Submit 1 Copy To Appropriate District Office	State of New Mexico	Form C-10	
District 1 - (575) 393-6161	Energy, Minerals and Adural Re		13
1625 N. French Dr., Hobbs, NM 88240 <u>District II</u> - (575) 748-1283	OIL CONSERVATION ON	65 5 (U) 30-025-01433	ļ
811 S. First St., Artesia, NM 88210 <u>District III</u> – (505) 334-6178	1220 South St. Francis D	1.5 Indicate Type of Leace	
1000 Rio Brazos Rd., Aztec, NM 87410	Santa Fe, NM 876		{
<u>District IV</u> - (505) 476-3460 1220 S. St. Francis Dr., Santa Fe, NM	KE	325641	
87505 SUNDRY NOT	ICES AND REPORTS ON WELLS	7. Lease Name or Unit Agreement Name	$\dashv$
(DO NOT USE THIS FORM FOR PROPO	SALS TO DRILL OR TO DEEPEN OR PLUG BAC	CK TO A	
PROPOSALS.)	CATION FOR PERMIT" (FORM C-101) FOR SUC		4

1. Type of Well: Oil Well Gas Well Other Injection  2. Name of Operator Sind Oct Forest LLC		8. Well Number 6  9. OGRID Number	
Fiint Oai	Energy, LLC	328733

3. Address of Operator 1703 Westfi	eld Loop Rd Houston, Tx. 77073	10. Pool name or Wildcat  Maljamar Grayburg San Andres	
4. Well Location	Coulb	1650 Wast	
Unit Letter K :	<del></del>	line and 1650 feet from the West line 33E NMPM Lea County	e
Section 16	Township 17S Range 11. Elevation (Show

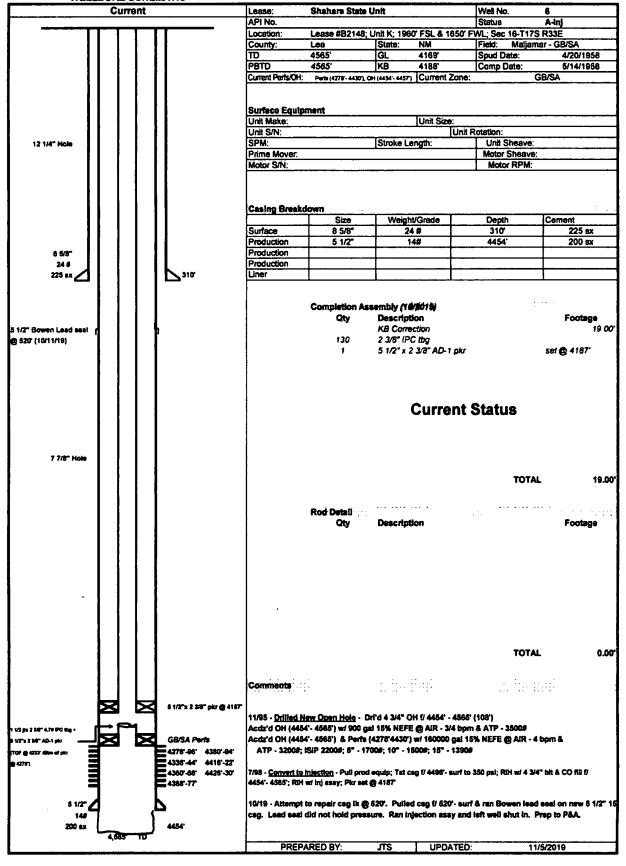
1. MIRU P&A equip	ment. POOH w/ injection assy.	_	
2. Set CIBP @ 4200	'. Pressure tst CIBP to 500 psi. Cap w	v/ 25 sx cmt.	
3. Circulate hole w/ 9		70.0	
<ol> <li>Spot 25 sx cmt @</li> <li>Spot 25 sx cmt @</li> </ol>		The same	
	surf. PJS Circ to sarF	70 E	
	verify cmt to surf - all strings) & weld or	n dry hole marker.	
		78	
		of 25 sx cmt.  Conditions When the conditions of	
c	Pie Peless Pees	<b>*</b>	
Spud Date:	Rig Release Date:		
I hereby certify that the information	above is true and complete to the best of r	ny knowledge and belief.	
100H		Mar	
SIGNATURE SIGNATURE	TITLE Operatio	ns MgrDATE11-5-2019	
Type or print name	nson je E-mail address:	ff@oaknrg.com PHONE: 832.262.9521	ĺ
For State Use Only	b nan access		
$\gamma_{\alpha}$		, <del>-</del>	
APPROVED BY: / LWW	Forther TITLE C. O.	A DATE 11-5-19
